SITE DEVELOPMENT PLAN

2165 JANITELL ROAD

Reviewed by:
Glenn Reese, P.E.
Stormwater Engineer II
GlennReese@ElPasoCo.com
719-675-2654

EPC STORMWATER REVIEW COMMENTS
IN ORANGE BOXES WITH BLACK TEXT

PLAN SHEET
DP 2.1 MVE PROJECT **61195**
MVE DRAWING **DP-PS**

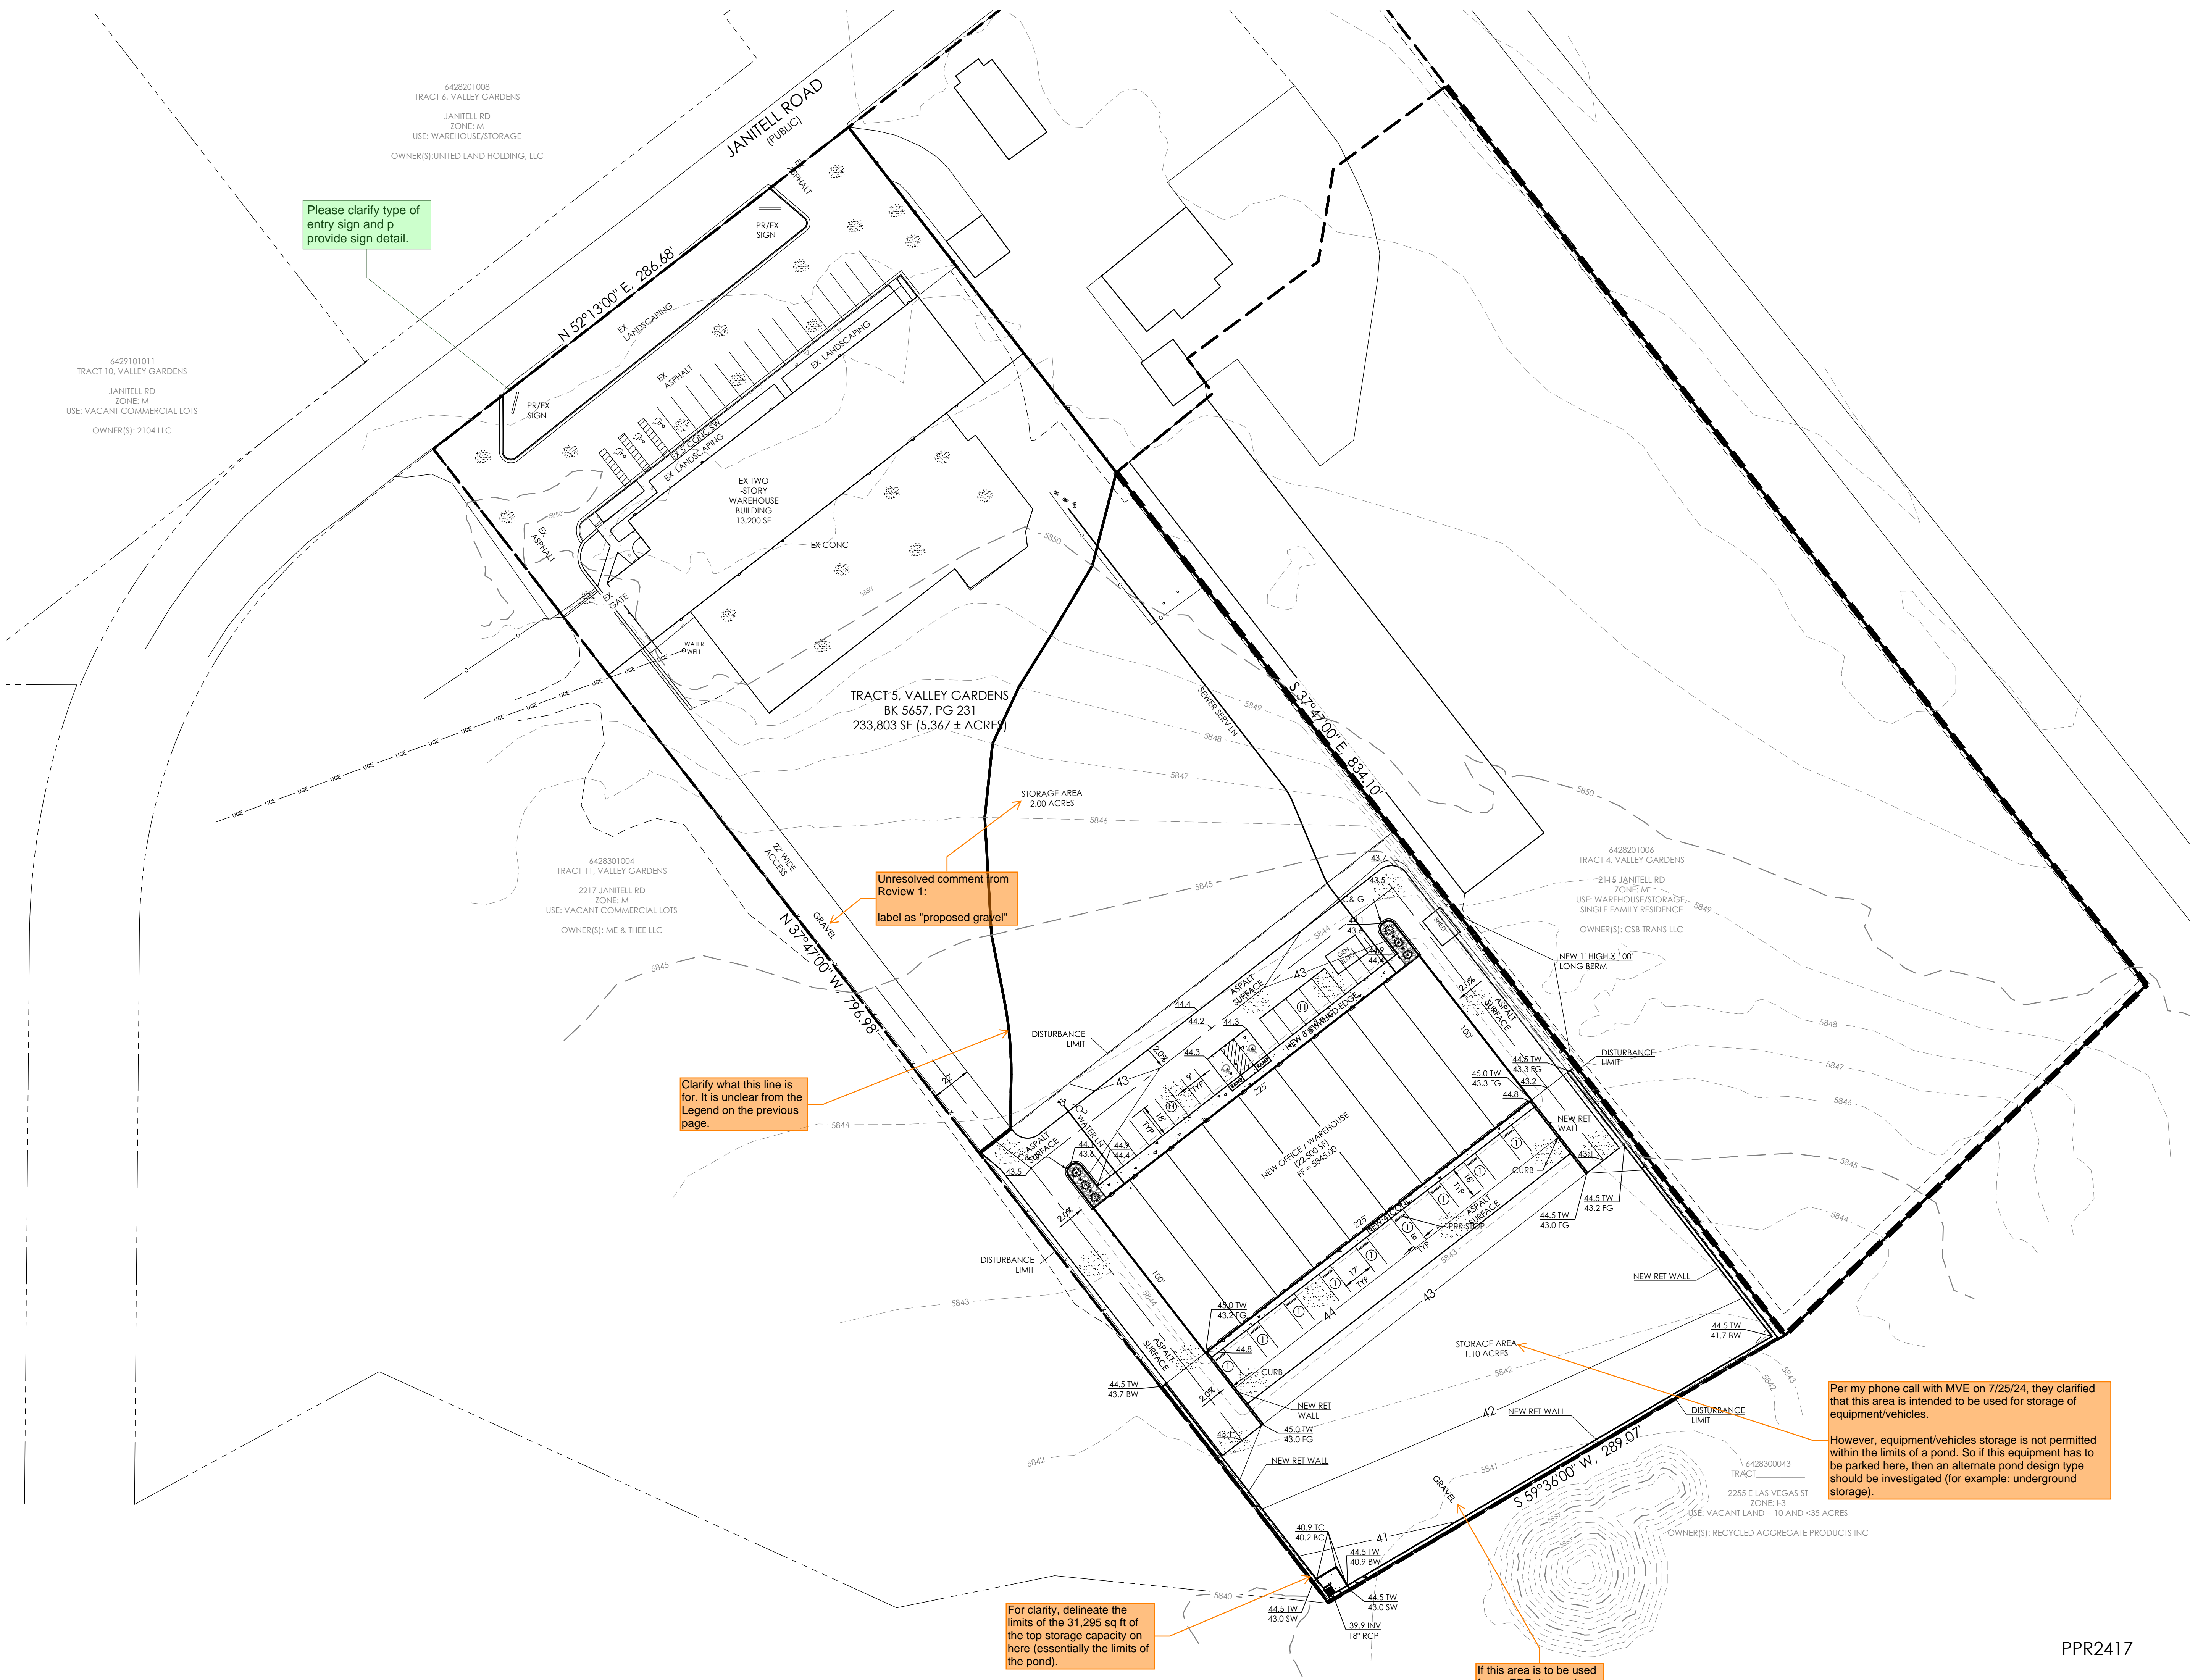
Unresolved comment from Review 1 revised for Review 2:
If scale is 1"=50' (which is what the scale bar shows), then revise the text below it that is 1"=40' Typical comment for all sheets.

Please clarify type of entry sign and provide sign detail.

Unresolved comment from Review 1: label as "proposed gravel"

Clarify what this line is for. It is unclear from the Legend on the previous page.

For clarity, delineate the limits of the 31,295 sq ft of the top storage capacity on here (essentially the limits of the pond).

If this area is to be used for an EDB, it must be vegetated.

Per my phone call with MVE on 7/25/24, they clarified that this area is intended to be used for storage of equipment/vehicles.

However, equipment/vehicles storage is not permitted within the limits of a pond. So if this equipment has to be parked here, then an alternate pond design type should be investigated (for example: underground storage).

Please provide building setbacks on all sides

SITE SIGNAGE
SCALE 1" = 1'-0"

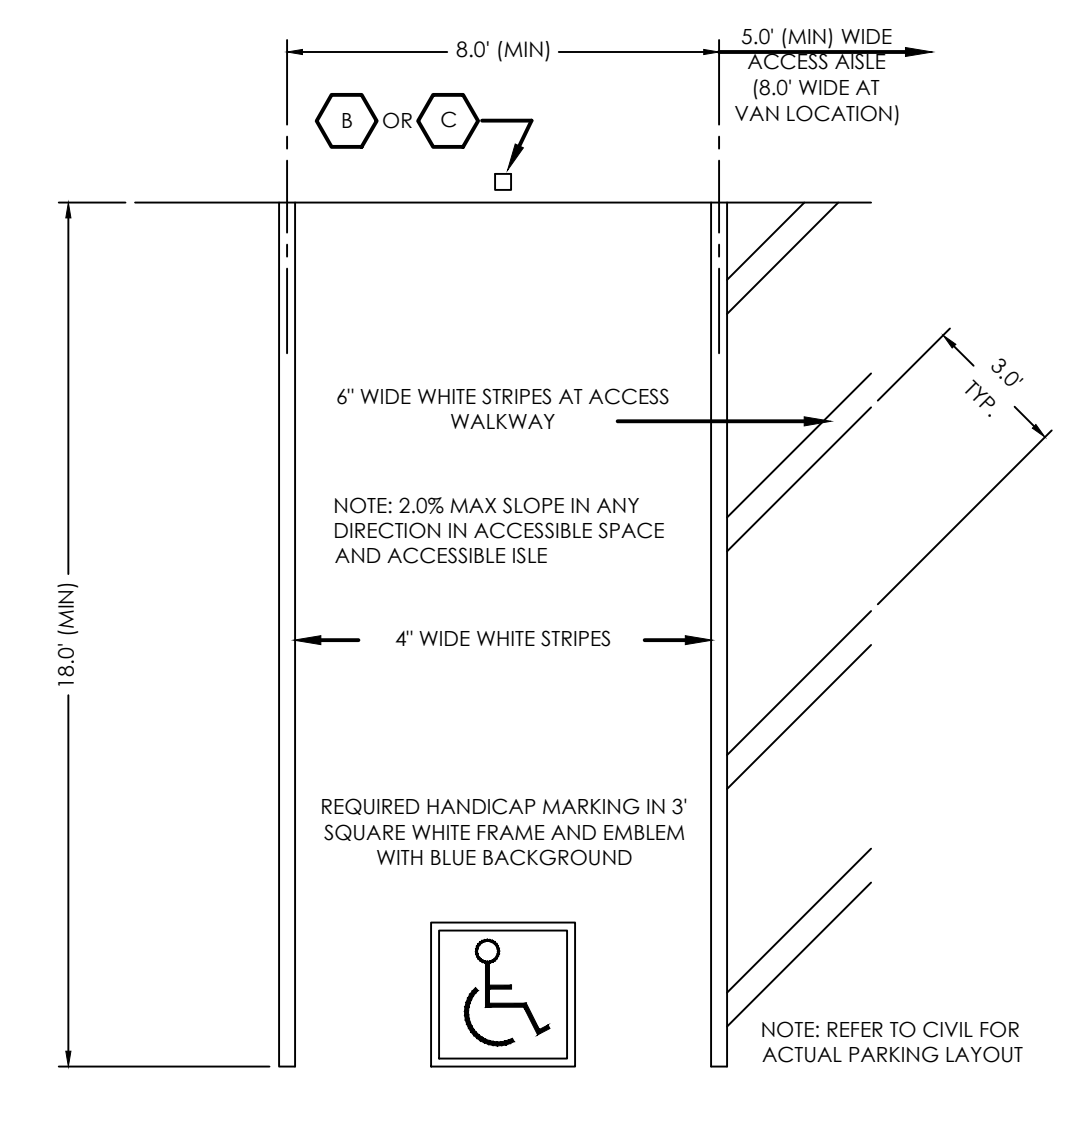
Any new signage proposed? It appears that signage either exists or is proposed in landscape areas near entrance drives.

TYPICAL HANDICAP PARKING SPACE
SCALE 1" = 4'-0"

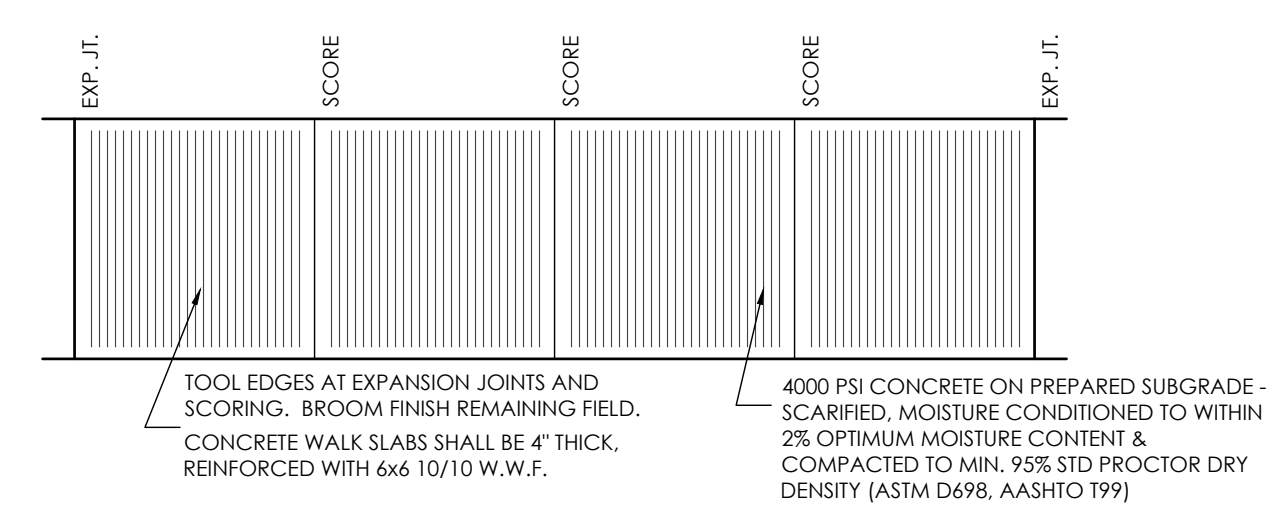
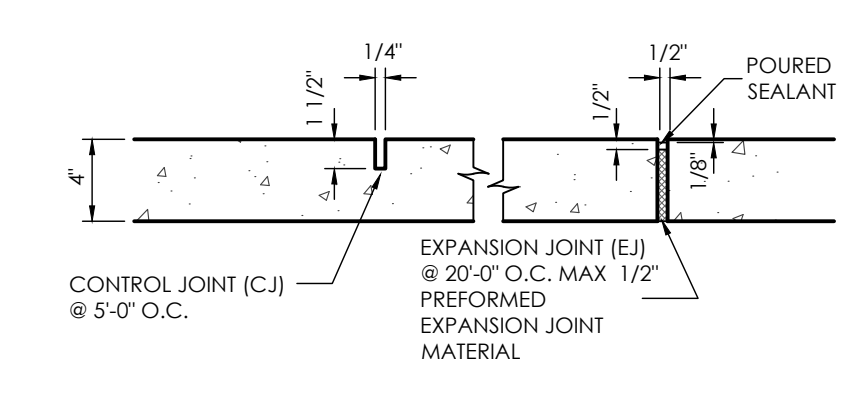
Provide standard parking space dimension detail (detail 11?)
